# 1321 Seneca

EARLY DESIGN GUIDANCE II | DPD #3012930 | JULY 18<sup>TH</sup>, 2012

# Proposed Departure

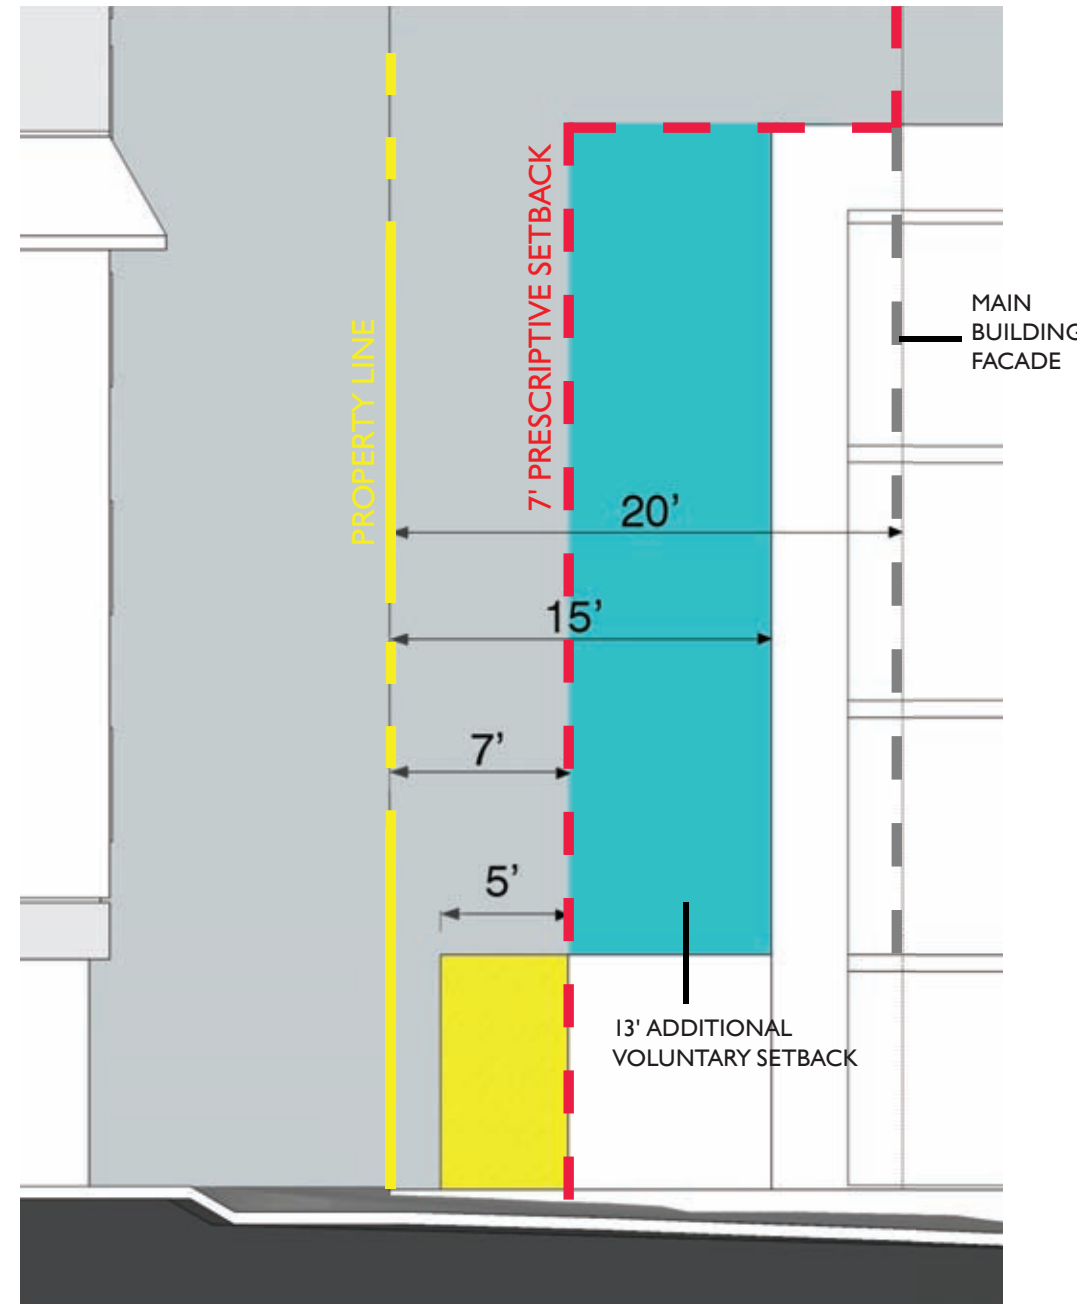
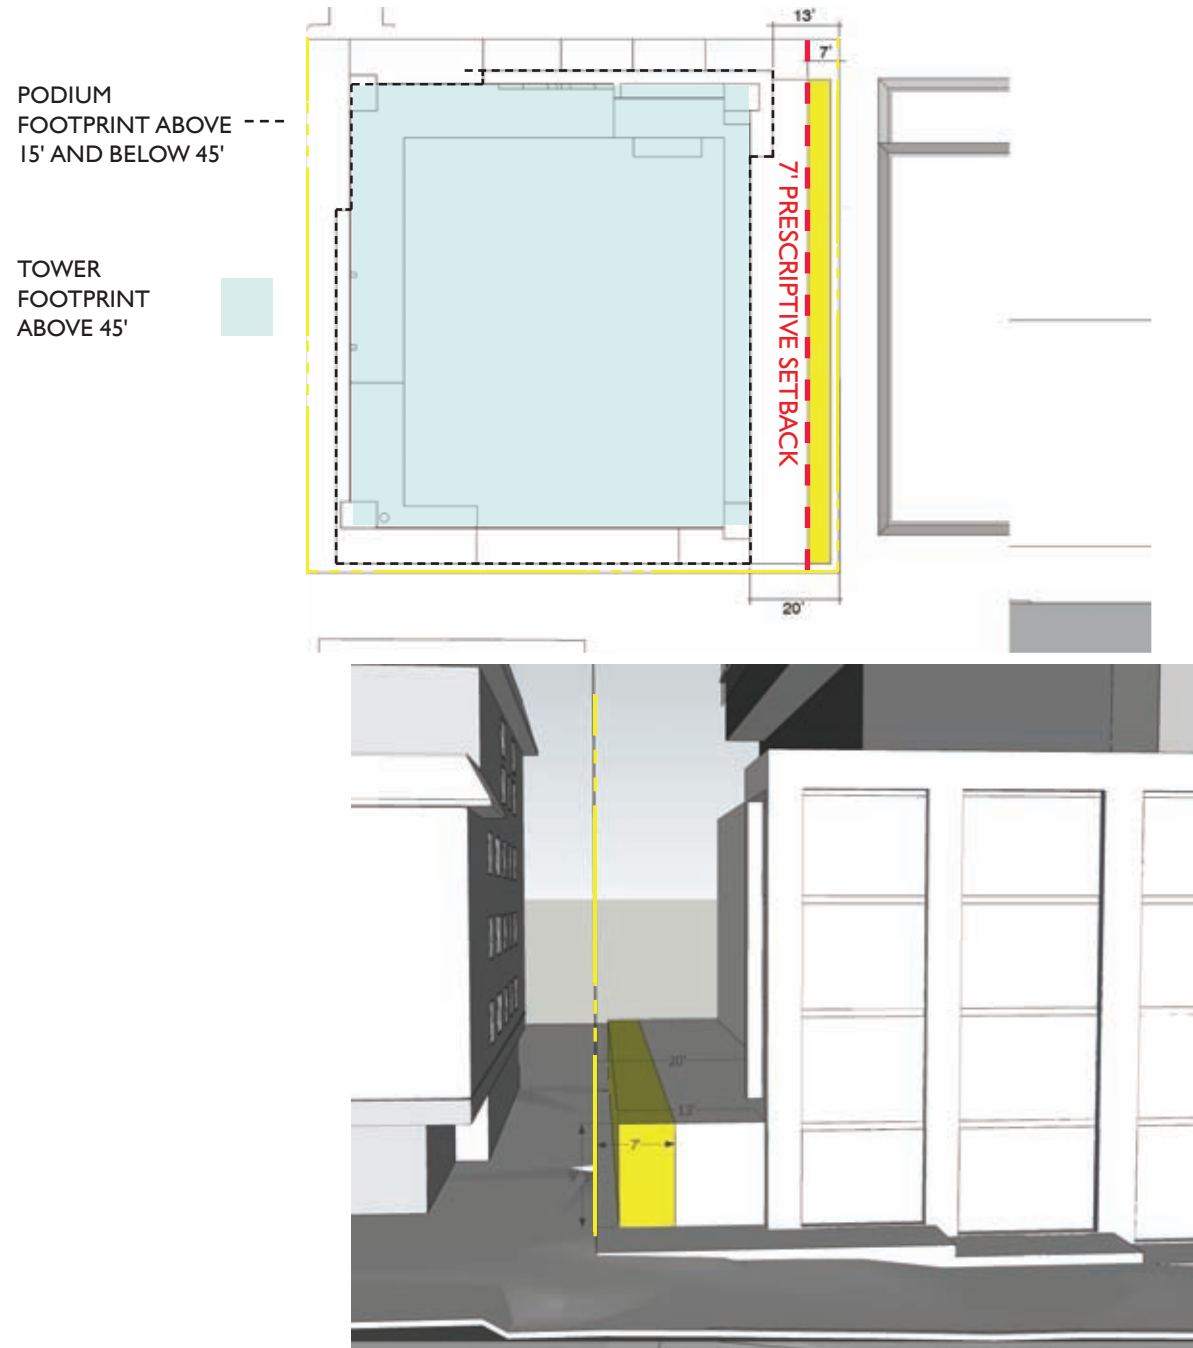
ITEM #	1
DEVELOPMENT STANDARDS	SMC 23.45.518 HR SETBACKS
PRESCRIPTIVE	At lot lines abutting neither a street nor alley: Portions of a structure 45' or below: 7' average setback, 5' min.
PROPOSED	At the lot line abutting the neighbor to the south: Portions of a structure 45' or below: 2' setback on ground floor and 15-20' set back on floors 2-4.
CONSIDERATIONS	Allows for a more generous separation between podium and neighboring building to the south.
